North Campus Faculty Housing Phase II  
Project No. FM110407L/986315

**Addendum No. 6**

ADDENDUM NUMBER 6  
to the  
CONSTRUCTION DOCUMENTS

**BUILDING 500B: SECTIONS**

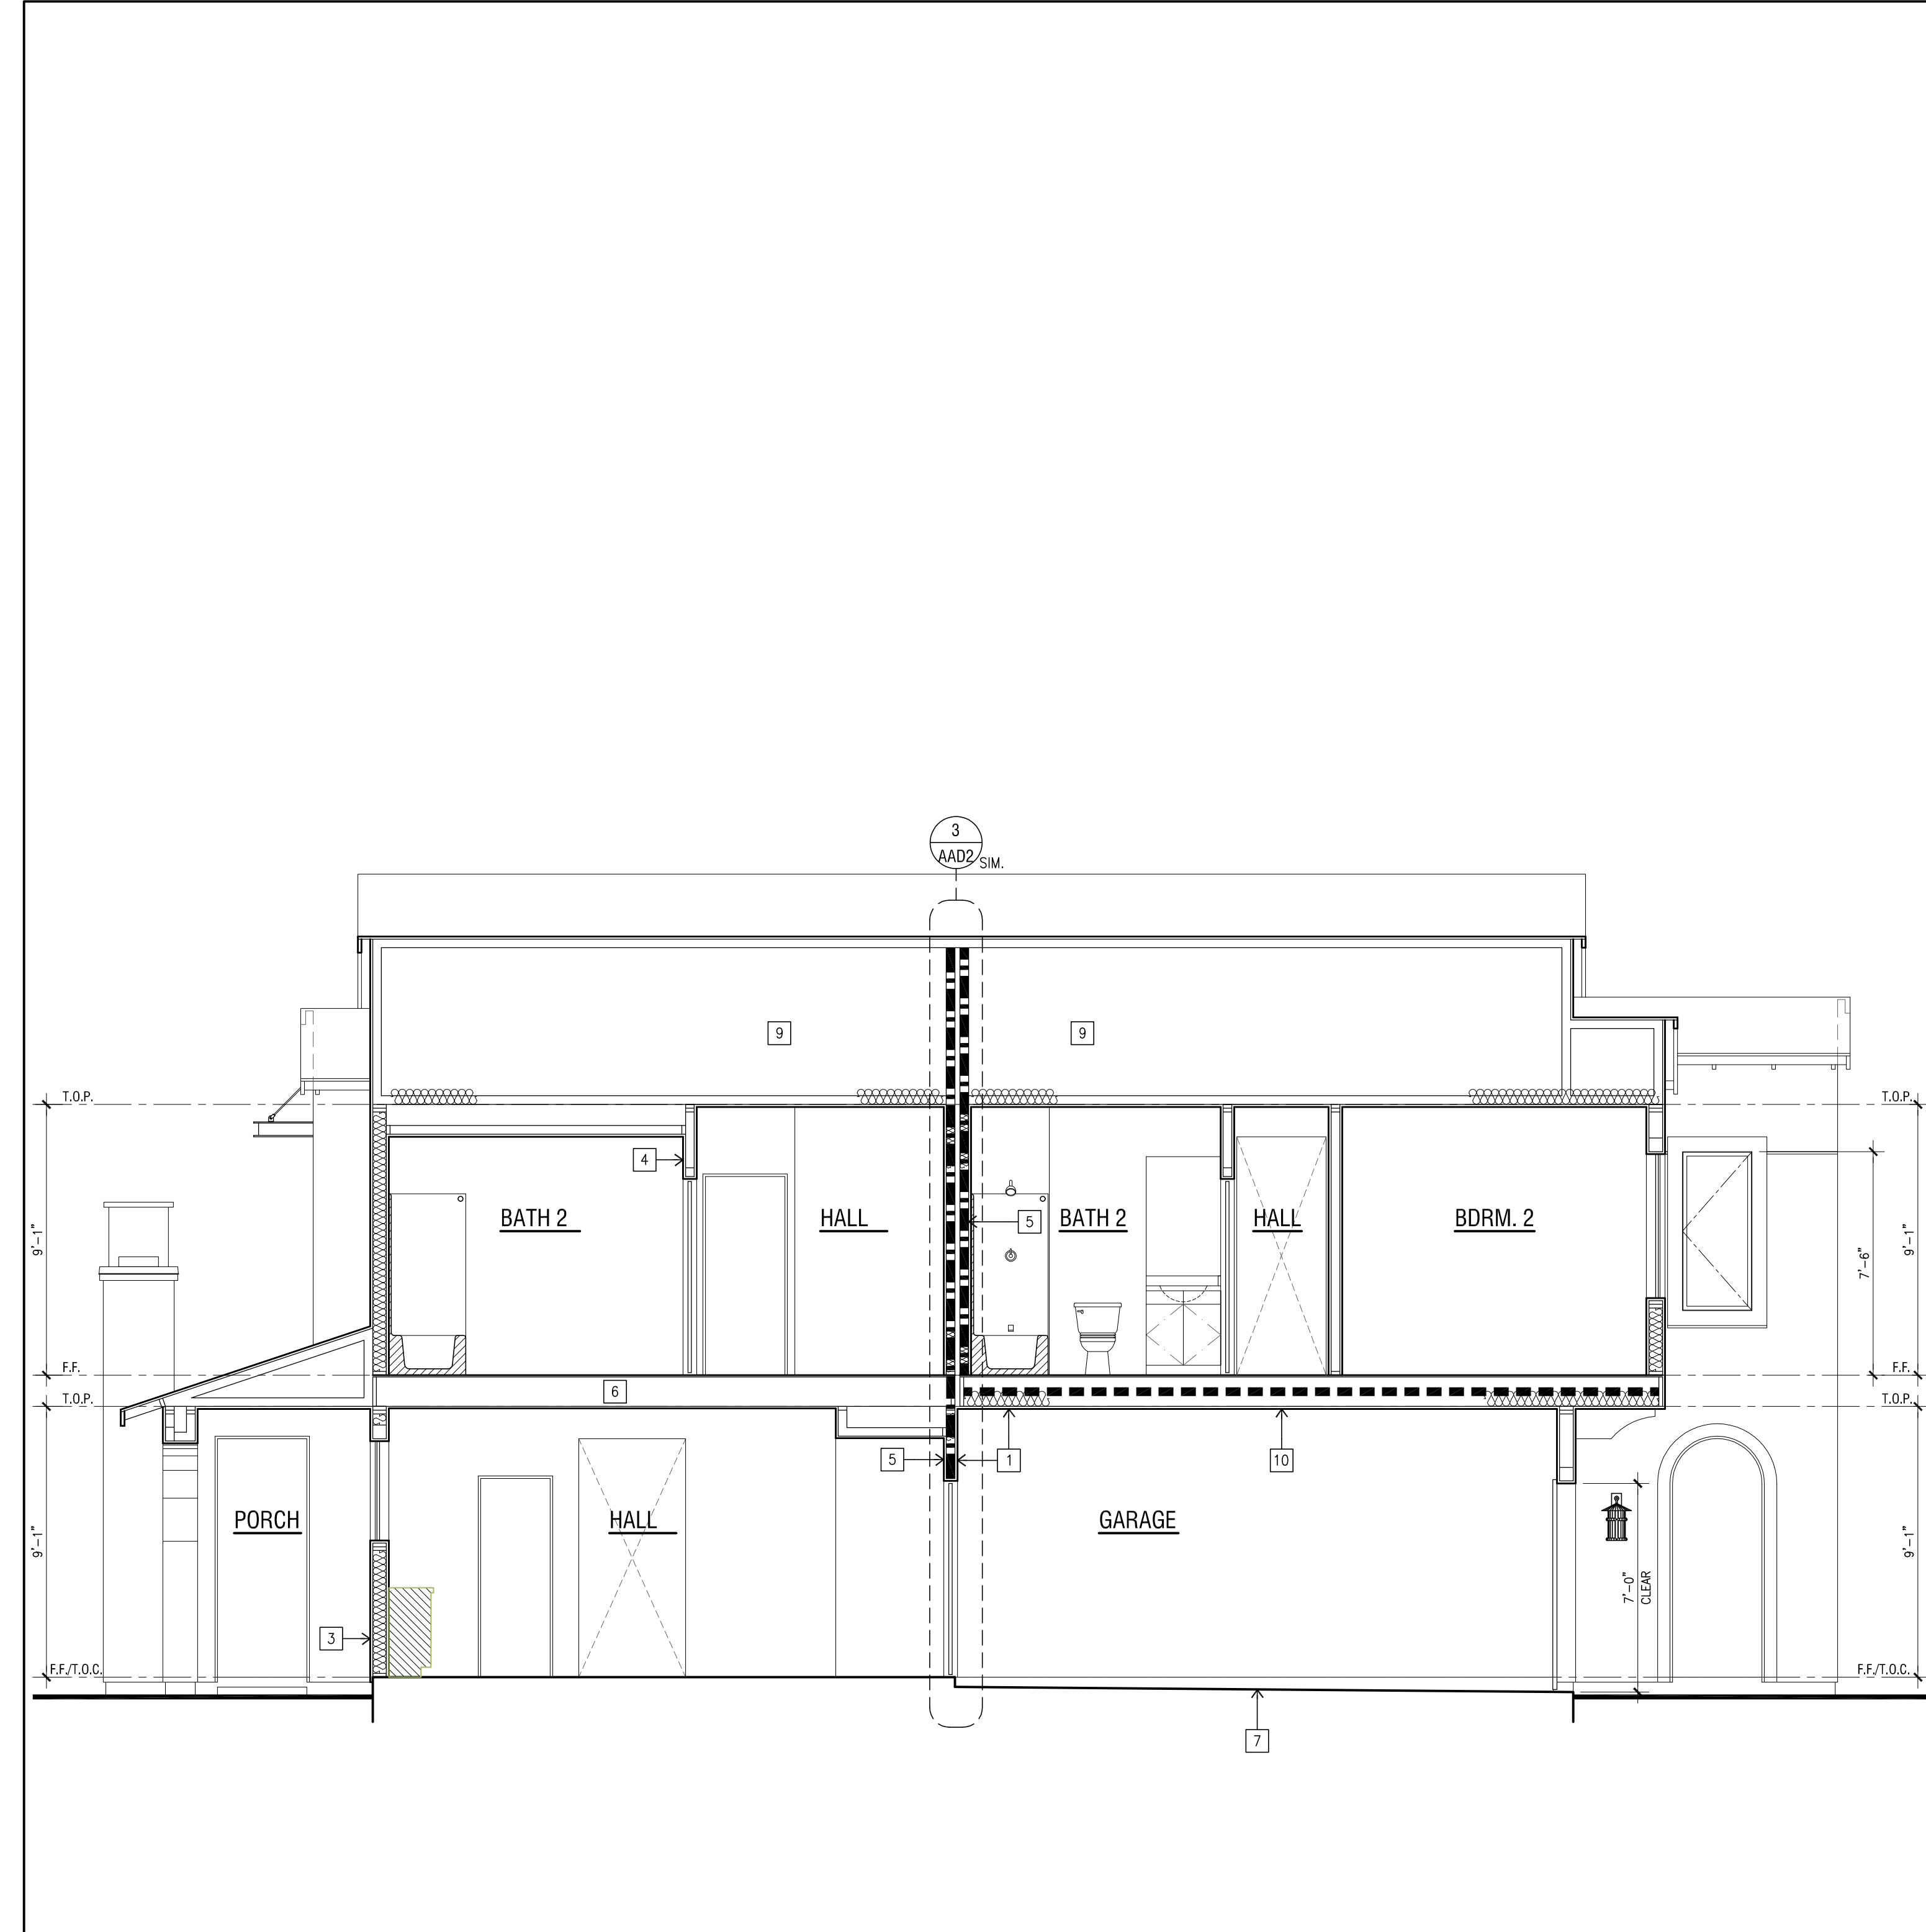
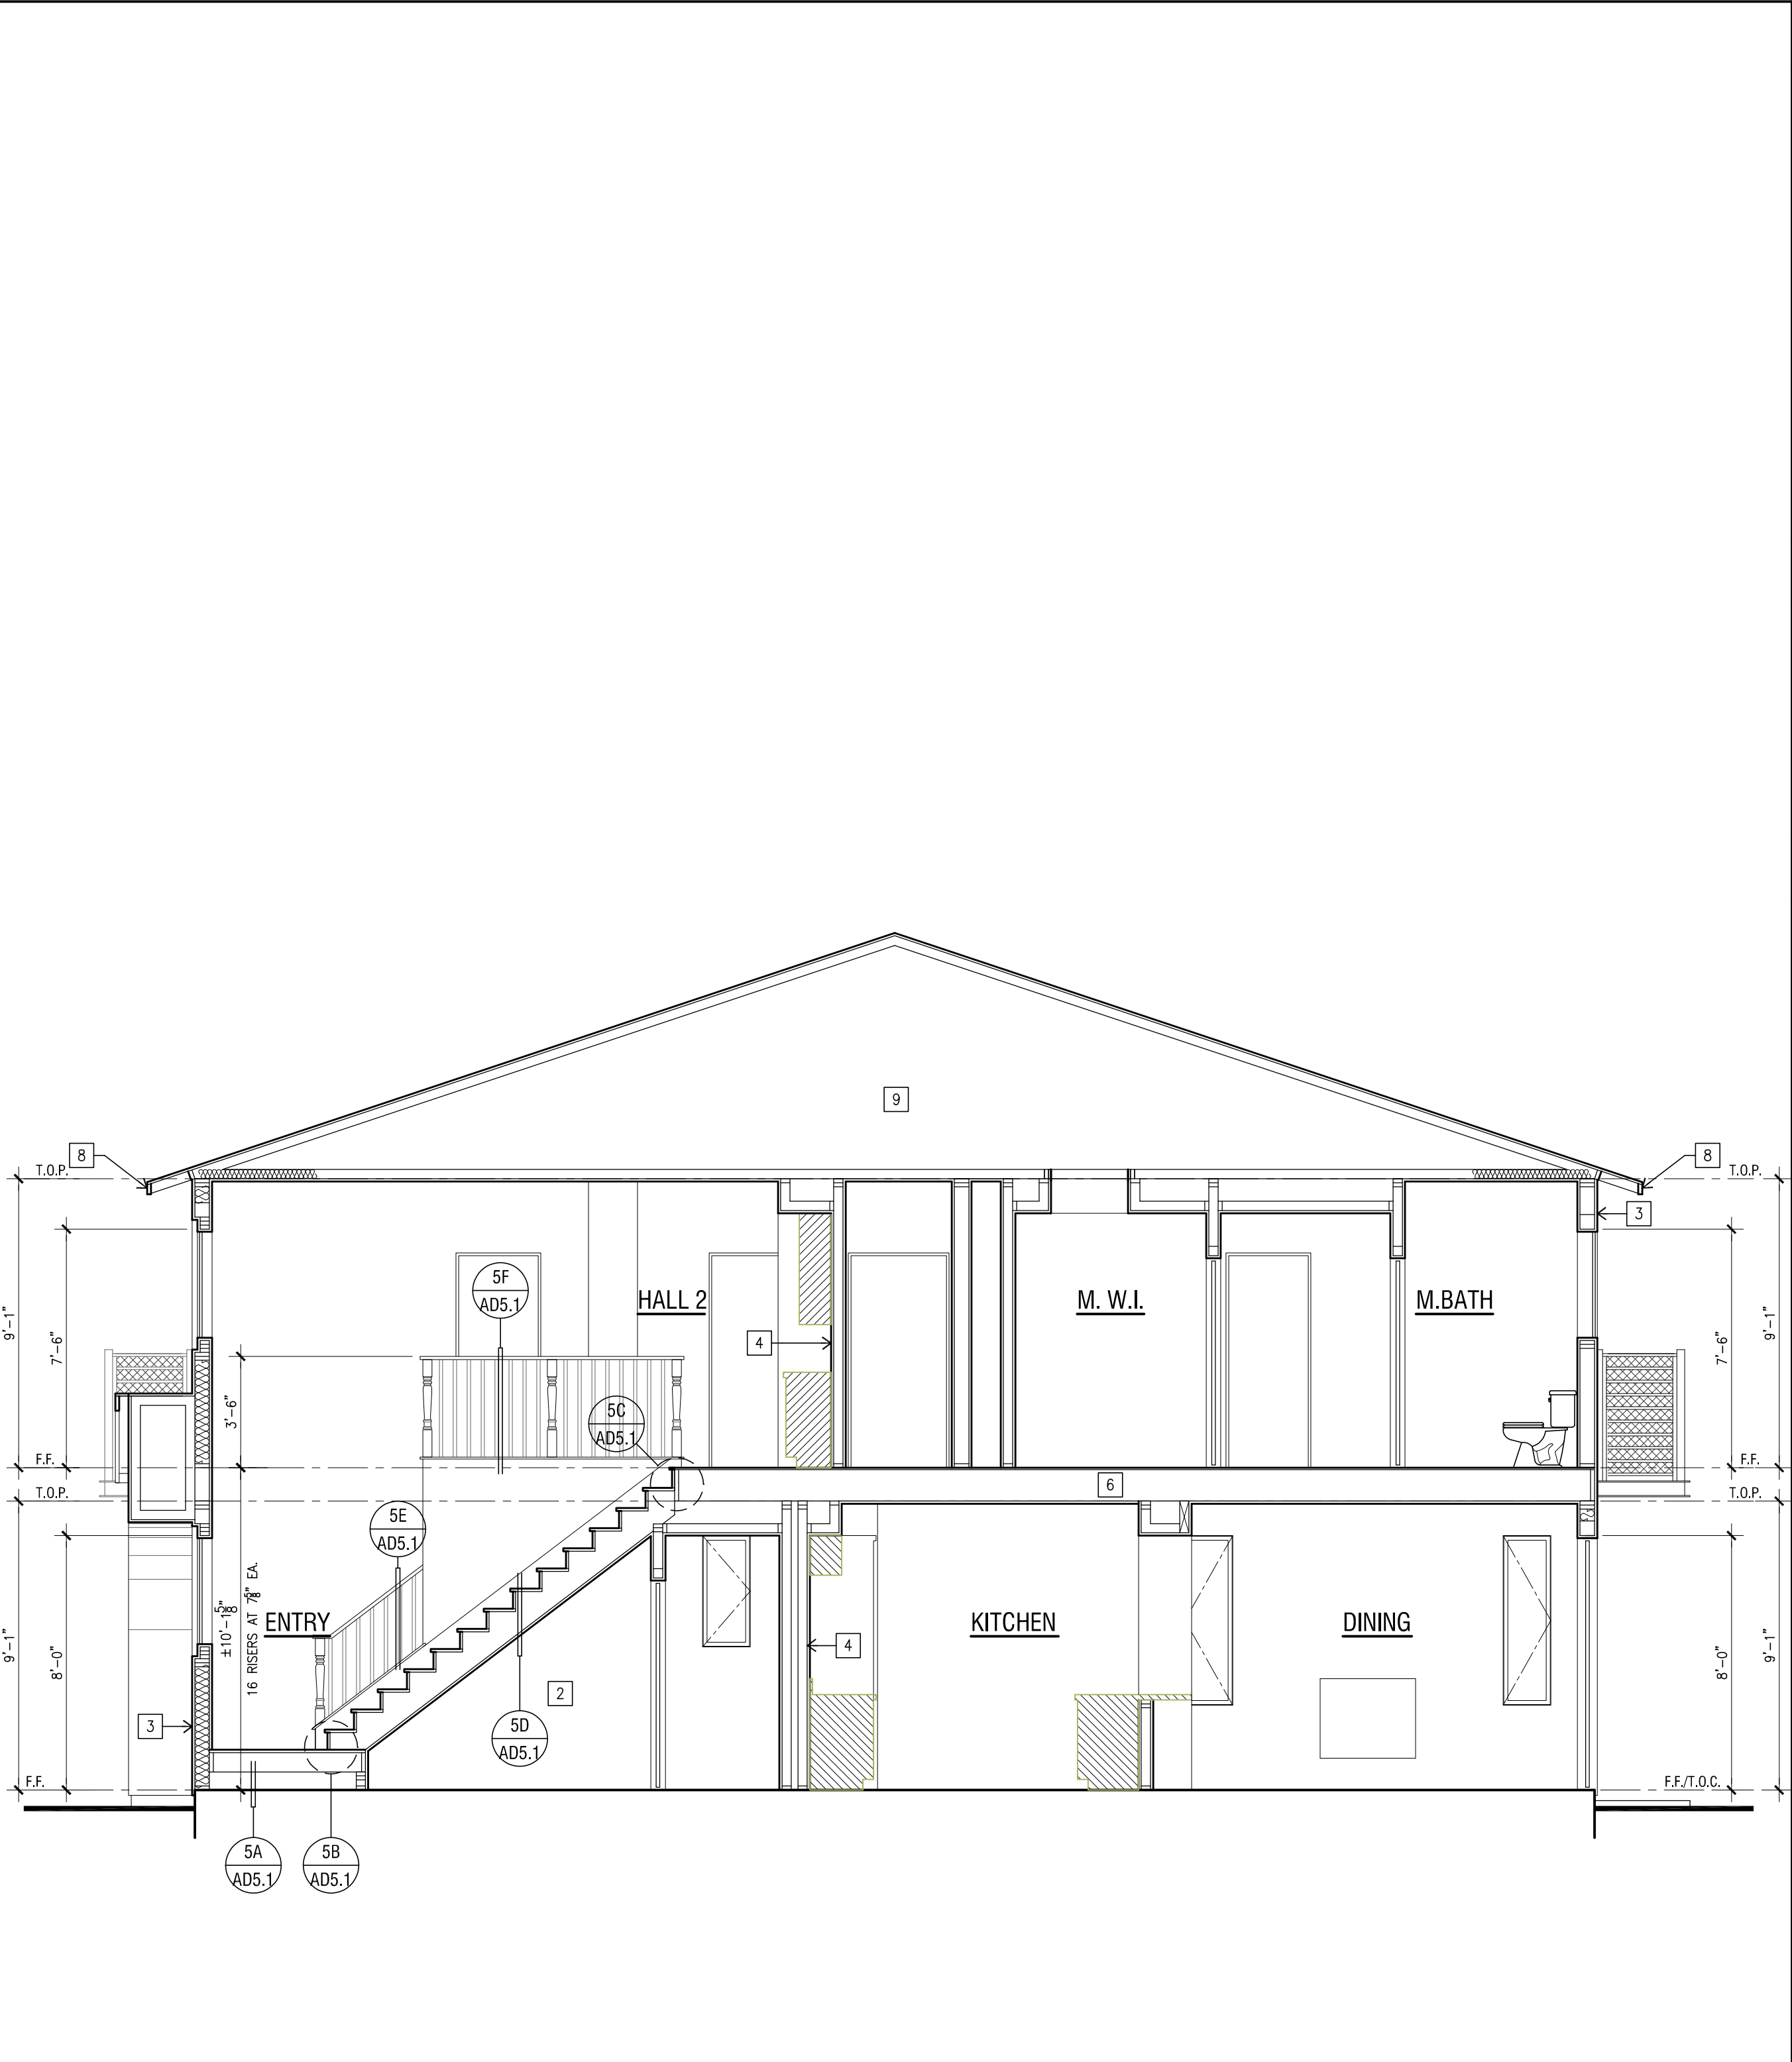
1. **Add** the attached Architect Sketches 1 of 8, dated 9/23/11.  
Sketch 1 of 8 Building 400A: Sections  
Sketch 2 of 8 Building 400B: Sections  
Sketch 3 of 8 Building 500B: Sections  
Sketch 4 of 8 Building 600A: Sections
